CIVA Free Known Programme 1 Power Intermediate / Yak-52, Advanced and Unlimited 2018

Guidance for competitors

Unlimited power category

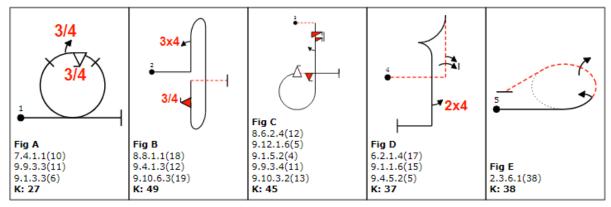
Note 1: Unlimited power Figure #3 has been revised from the original version

- ullet The duplicated 2x4 roll (9.5.4.2) after the spin is now changed to a ${\it \%}$ roll (9.1.5.2)
- The flick-roll pair is now set to opposite directions per Aresti regulations

Note 2: Unlimited power Figure 'E' 2.3.6.1 is within the revised 2018 CIVA Section 6 Part 1 para 2.2.1.8 versatility range.
